Type Coffee Vending Machine	Model ES7300 – FB7300	T.I. NO 03 - 2016
Serial Number 54613918 (ES7300) 60110671 (FB7300)	Subject TASTE IMPROVEMENTS FOR HOT WATER	ISSUED FOR (X) Action Information X

The goal is to improve the taste of the hot water selection.

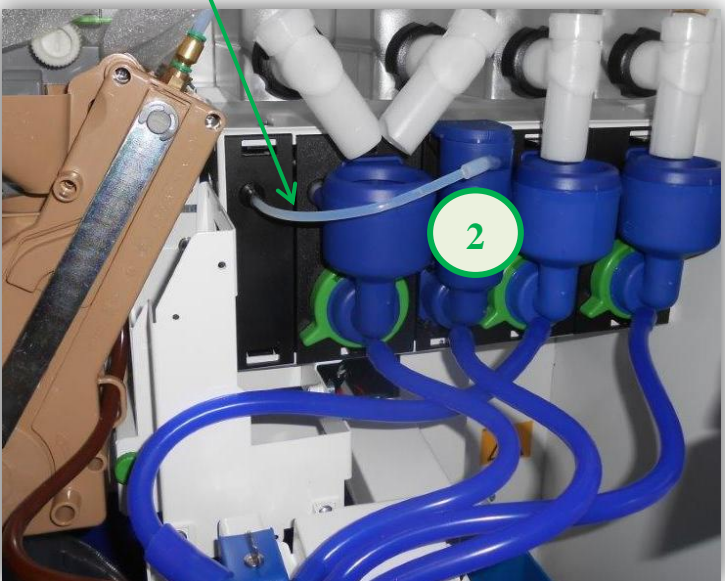
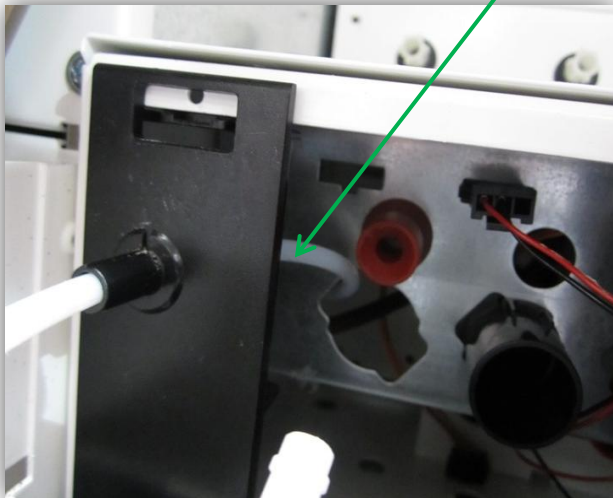
- ES7300** The silicone hose that connect the boiler outlet (**pos. 1**) to hot water dispensing spout (**pos. 2**) is replaced by a **teflon** hose: (**pos. 1** → **pos. 2**)

In addition it's required to replace on the manifold the hose – fitting and its OR with a **L – shape coupling** .

? pieces of **blue silicone** hoses are also required.

*L - Shape coupling 5 x 1/8*  
Spare part code: **0V2509**

**Teflon hose 2.5x5 – Lg. 450 mm**  
Spare part code: **252659** (minimum order 1 m)  
It replaces a silicone hose 3x6 – Lg. 260 mm
